**CITY OF SEATTLE
ANALYSIS AND DECISION OF THE DIRECTOR OF
THE SEATTLE DEPARTMENT OF CONSTRUCTION AND INSPECTIONS**

Application Numbers: 3022596, 3020898, 3023474
Applicant Name: Julian Weber, JW Architects for Isola Homes
Address of Proposal: 1638, 1640, 1644 20th Ave

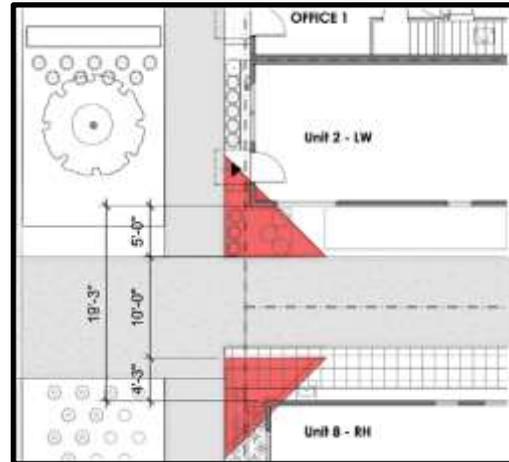
1. **Driveway Width (SMC 23.53.025.D):** Vehicle access easements serving ten or more residential units, easement width shall be a minimum of 32' and provide a surfaced roadway at least 24' wide.

The applicant proposes a 10' curb cut and 14' drive. Hardscape of drive to consist of 9' of concrete and 4' of pedestrian walkway made of pavers.

- Sight Triangle (SMC 23.54.030.G.1):** The Code requires a sight triangle be provided on both sides of the driveway be kept clear of any obstruction for a distance of 10 feet from the intersection as shown in red on the right.

The applicant proposes to encroach into both sides of the sight triangle by 1.5' on unit 8 and 3' for Unit 2 and the trash enclosure.

The Board unanimously approved the departure request as the reduced aisle width presents a more continuous wall of building and deemphasize the automobile's presence at the street. The resulting design better meets the intent of Design Guideline PL2-D Walkability and Wayfinding and DC1-C-2 Reduce Visual Impacts of Parking Lots.

The Board unanimously approved the departure as strict application of the code would require one of the live/work and rowhouse units to be setback further than the existing commercial building to the north. This would reduce the continuous rowhouse appearance the Board wanted to see for 20th Street allowing for interaction opportunities for residents of the rowhomes, businesses in the live/work units, and neighbors, the intent of Design Guideline PL3-B-4 Residential Edges - Interaction.
